**SR-2 – ADVISORY STAFF REPORT (04-03-2026)**

**ADDRESS:** 264 WATSON

**HISTORIC DISTRICT:** BRUSH PARK

**APPLICATION NUMBER:** HDC2026-00106

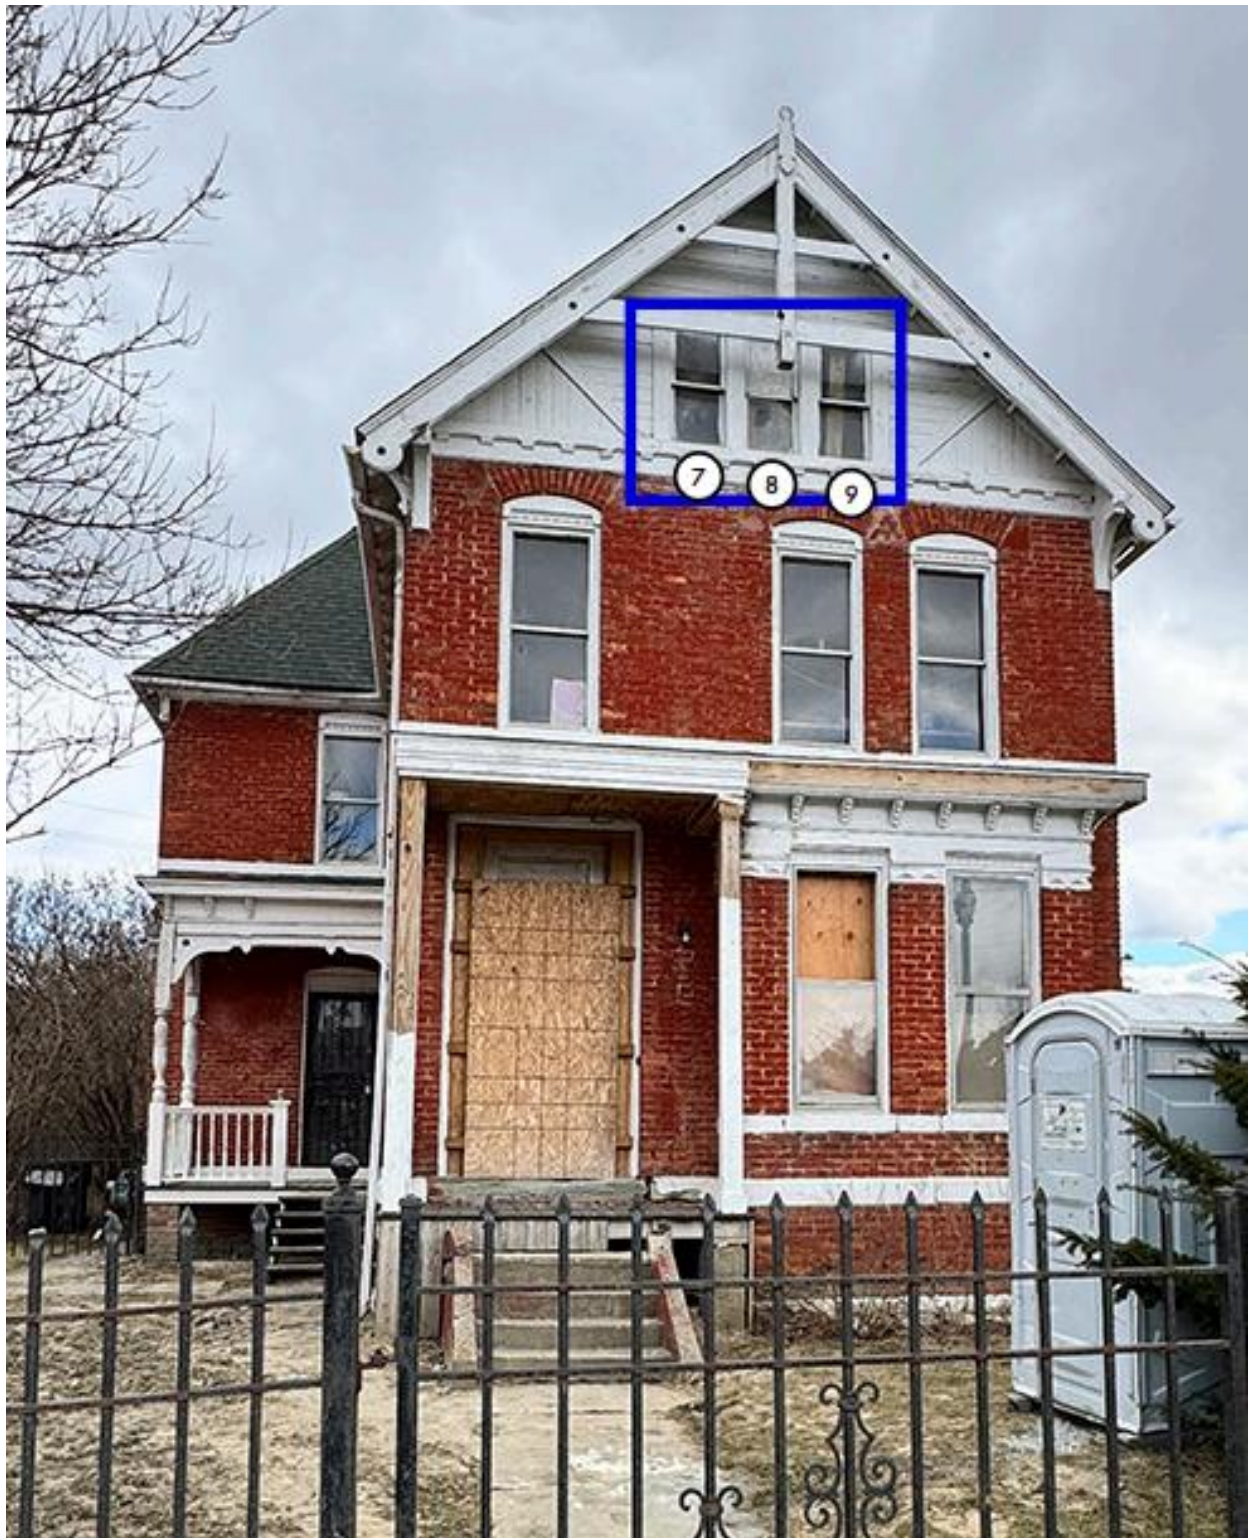
1. The extant wood windows are distinctive and historic character-defining features of the building. The submitted application materials do not substantiate that these windows are deteriorated beyond repair

- It is staff's opinion that the wood window sashes and associated brickmould/casing proposed for removal are historic, distinctive character-defining features of the house.

- It is staff's opinion that the submitted documents do not support the assessment that the building's wood windows are deteriorated beyond the point of reasonable repair. Therefore, their removal and replacement with new windows does not align with the Standards.

- Should the Commission determine that the proposed work items are appropriate and issues a Certificate of Appropriateness for the project, staff notes that the application does not depict how the arched portion will be matched. Any approval should be conditioned upon the applicant submitting this information to staff for review and approval prior to the issuance of the COA.

1. The extant wood windows are distinctive and historic character-defining features of the building. The application does not adequately substantiate that the existing wood windows proposed for replacement are deteriorated beyond repair.
